SUBMITTAL SUMMARY REPORT 31051

PLAN NAME: MARO 111 - PUD MASTER PLAN

SUBMITTAL	STARTED	DUE	COMPLETE	STATUS
OCE: Plan Review Revision (DR) v.2	06/11/2026	06/18/2026	06/23/2026	Approved
OCE: Plan Review Revision (DR) v.1	05/13/2026	05/28/2026	06/02/2026	Requires Re-submit
OCE: Plan Review (DR) v.1	10/16/2024	10/23/2024	11/26/2025	Approved

REVISIONS	
DATE	
MASTER UTILITY PLAN	
MARION P.U.D. WESTPOINTE P.U.D. MARION COUNTY, FLORIDA	
DATE: 08-08-26	DRAWN BY: JIB
CHECKED BY: JIM	FORNO: 22-8661
SHEET: 08_01

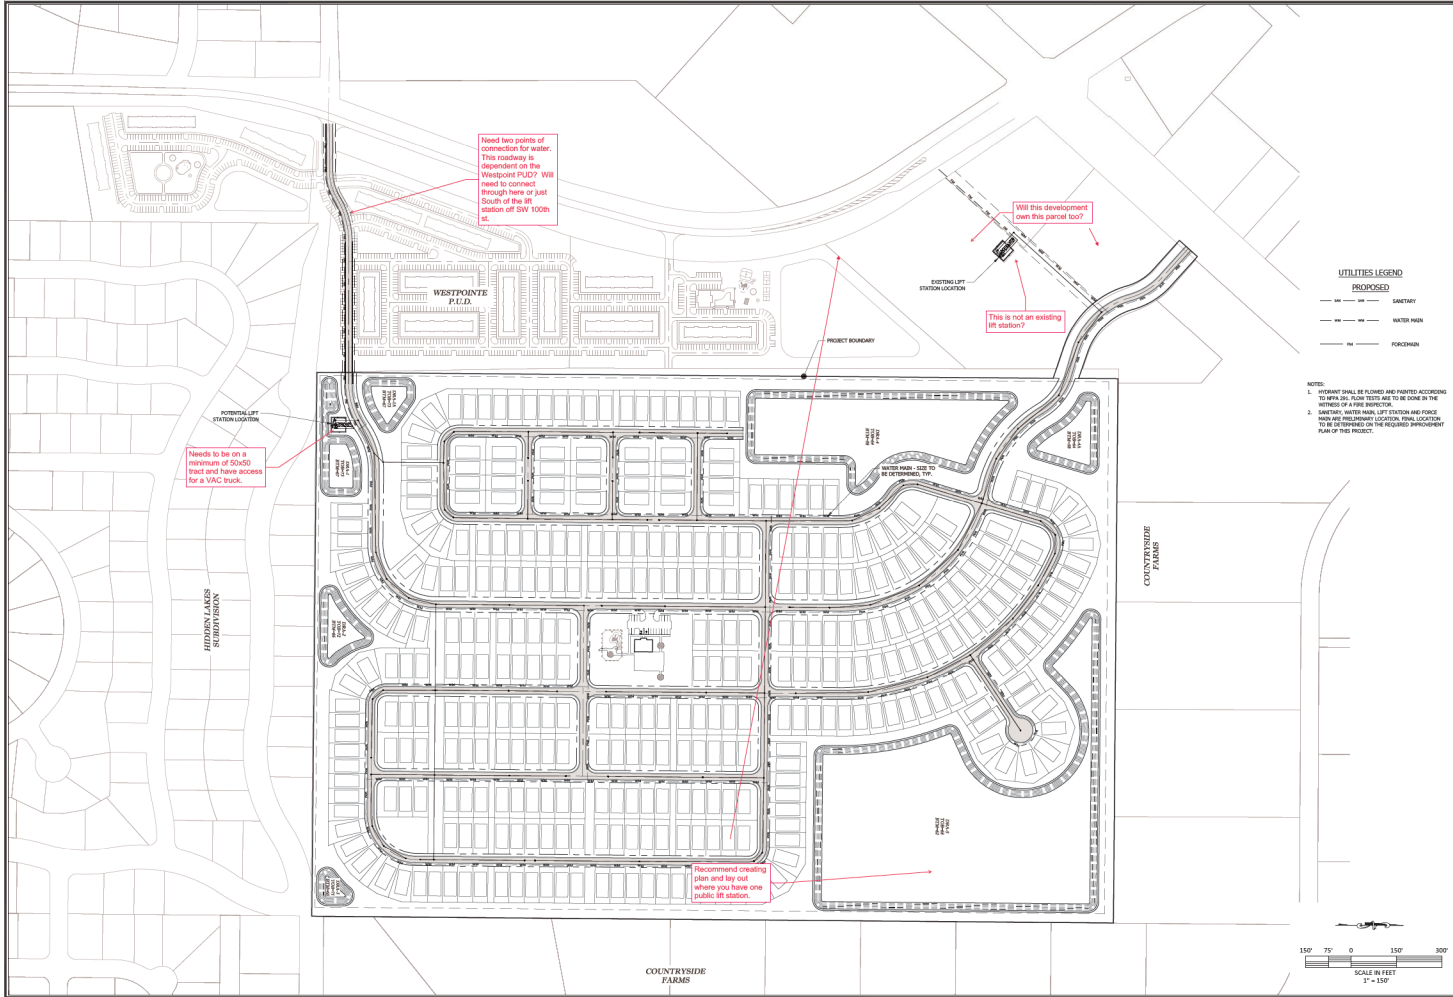
Heather Proctor	Needs to be on a minimum of 50x50 tract and have access for a VAC truck.	05/26/2026 8:39	PMMar0 III - PUD Master Plan.pdf	9
Heather Proctor	Need two points of connection for water. This roadway is dependent on the Westpoint PUD? Will need to connect through here or just South of the lift station off SW 100th st.	05/26/2026 8:40	PMMar0 III - PUD Master Plan.pdf	9
Heather Proctor	Phasing plan doesnt work with sewer design.	05/26/2026 8:43	PMMar0 III - PUD Master Plan.pdf	12
Heather Proctor	Recommend creating plan and lay out where you have one public lift station.	05/26/2026 8:45	PMMar0 III - PUD Master Plan.pdf	9

REVIEWER	MARKUP	DATE/TIME	FILE NAME	PG #
Heather Proctor	if you keep the "existing" lift station, you will need this easement for phase 1, to complete the utility construction.	05/26/2026 8:46	PMMaro III - PUD Master Plan.pdf	12
Heather Proctor	Utility plan shows sewer stopping in the middle of phase 2? Feeding to the proposed lift station to the North	05/26/2026 8:47	PMMaro III - PUD Master Plan.pdf	12
jrivera	Where is additional open space originating from?	05/28/2026 8:55	PMMaro III - PUD Master Plan.pdf	7
jrivera	2 signs proposed at each entrance and details below seems to imply that each sign is double-faced (totaling 256 SF of sign area per entrance). Per LDC Sec. 4.4.4.C(5), sign at entrance may be a single sign with 2 faces of equal size OR may be a SINGLE face sign located on each side of the entrance. Please provide correct	05/29/2026 1:16	PMMaro III - PUD Master Plan.pdf	11
jrivera	These signs are considered off-site signs and cannot be permitted as on-site signs. Please remove.	05/29/2026 8:59	PMMaro III - PUD Master Plan.pdf	11

MARION FRIENDLY LANDSCAPE AREA (MFLA) BUFFER & TREE PRESERVATION PLAN

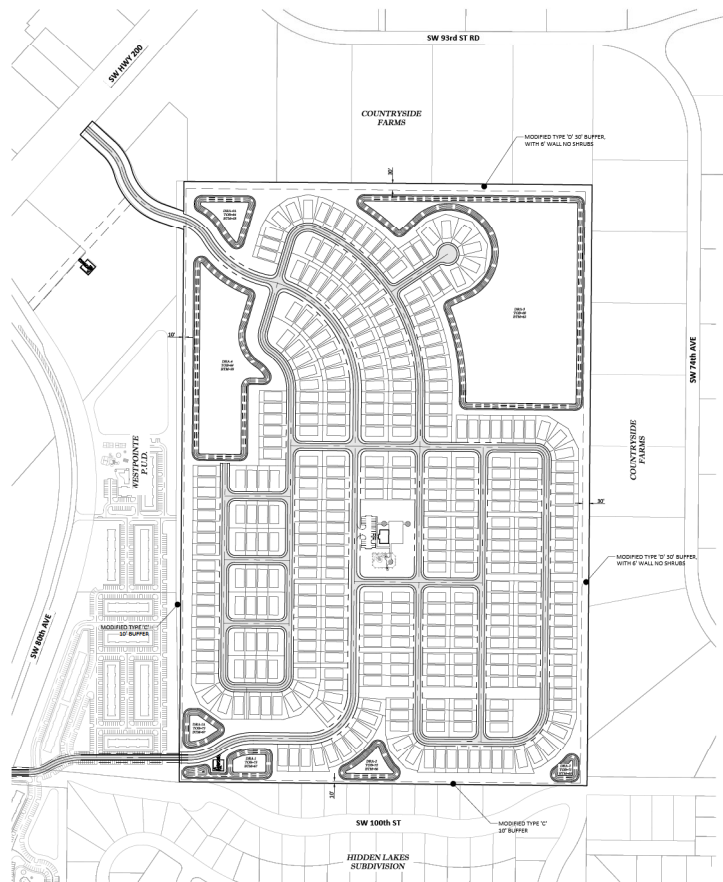
<i>Corrections</i>	2.12.24 - Landscape requirements/6.8.6 - Buffering (Resolved) - [INFO] Reference to continuous hedge on buffer detail was removed and now only indicates trees. Applicant should be aware that this does not absolve from shrub/groundcover requirements in future development review stages, as indicated in provided buffer description. [INITIAL] Please note Buffer drawing and description seem to not completely align. Please update buffer detail/description consistent with approved PUD plan/conditions.			
<i>Corrections</i>	2.12.5/1.8.2.D - Traffic Concurrency Evaluation? (Resolved) - [INFO] Please coordinate with OCE regarding any improvements based on traffic impact analysis			
<i>Corrections</i>	2.12 - Zoning Classification-adjacent properties (Resolved) - [6/18/26] Updated. [INITIAL] Please see mark-ups on zoning sheet. Please indicate parcel number and delineate parcel boundaries/ROW on zoning sheet for clarity

SHEET: 11.01

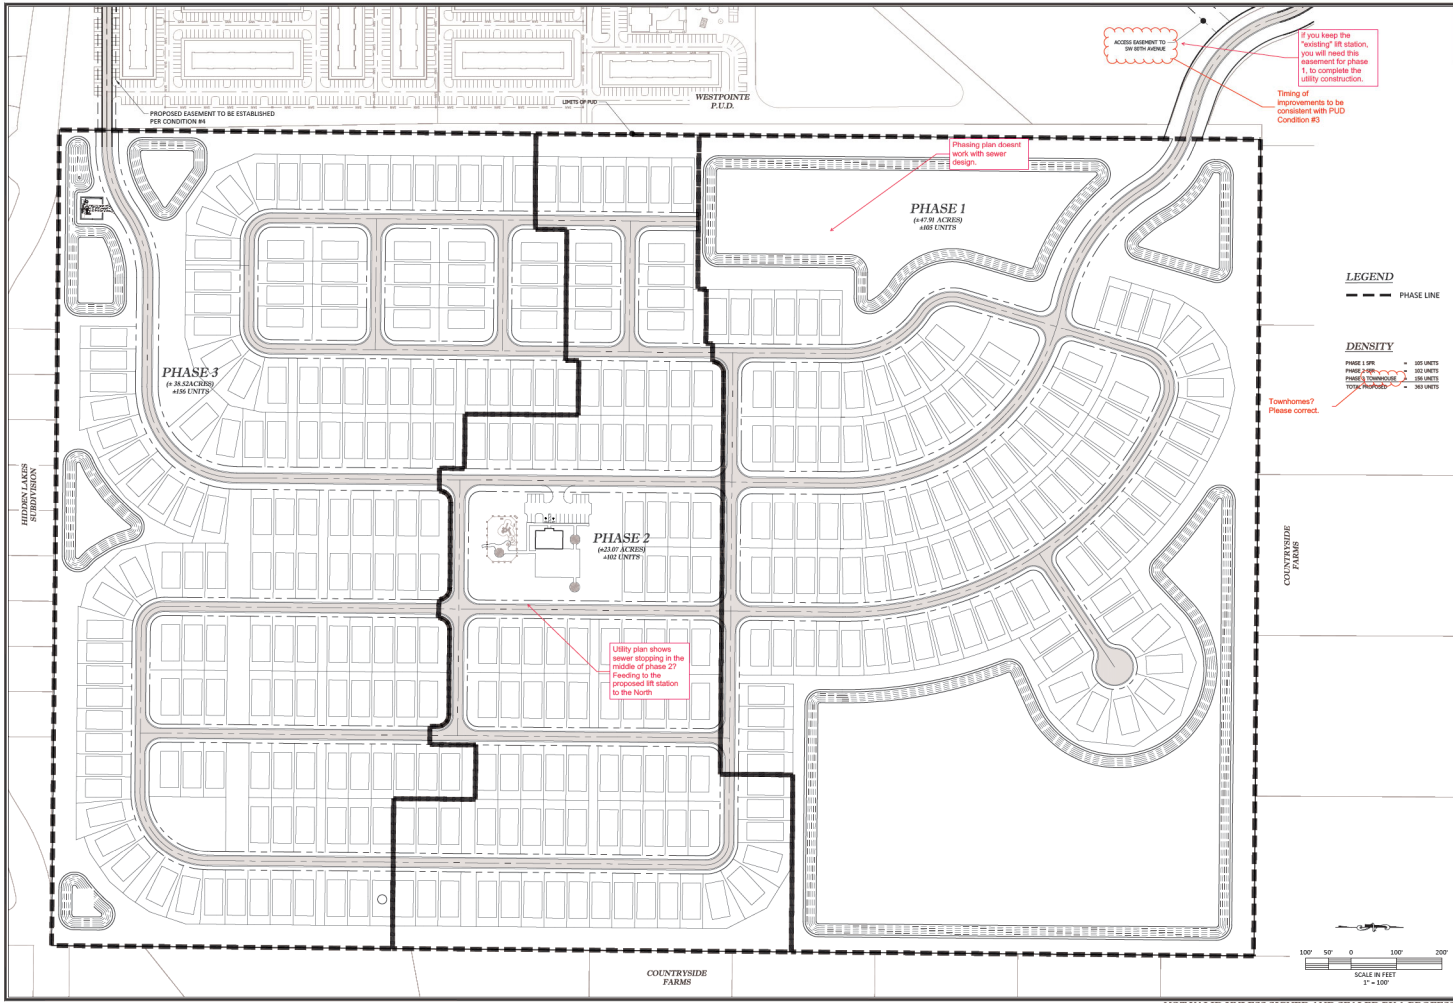
OCE: Plan Review Revision (DR) v.2				
ITEM REVIEW NAME (DEPARTMENT)	ASSIGNED TO	DUE	COMPLETE	STATUS
911 Management (DR) (911 Management)	Jamie Waldron	06/18/2026	06/18/2026	Informational
<i>Corrections</i>				
Additional 911 Comments (Resolved) - Corrective Action: Sheets 06.01, 07.01, 08.01, 09.01, 10.01, & 11.01 have SW 77th Avenue Rd incorrectly labeled as SW 75th Avenue Rd. - Additional Comments:

<i>Corrections</i>	2.12 & Article 5 - Overlay zones (Resolved) - [INFO] (1) FEMA Flood Zone X, AE; (2) Secondary Springs Protection Zone; (3) No ESOZ			
<i>Corrections</i>	Additional Growth Services comments (Resolved) - [6/18/26] (1) Sheet 11.01 updated. (2) Staff acknowledges that provided SFR lot type is same as previously-approved PUD master plan. [INITIAL] (1) Per PUD condition 3, parallel access connection shall be obtained and established as a minimum subdivision improvement for the project OR first phase. Please update call-out on phasing plan accordingly. (2) Please confirm Typical 50' lot type is being utilized for entire project instead of "Villas" lot types			
<i>Corrections</i>	2.12/6.11.6 - Construction access (Resolved) - [INFO] Defer review to OCE			
<i>Corrections</i>	2.12/2.12.21 - Open space and natural areas (Resolved) - [6/18/26] 20% open space indicated. [INITIAL] Provided open space figures seem to be below 20% thresholds. Where is additional open space originating from? Please correct master plan to provide at least 20% open space.
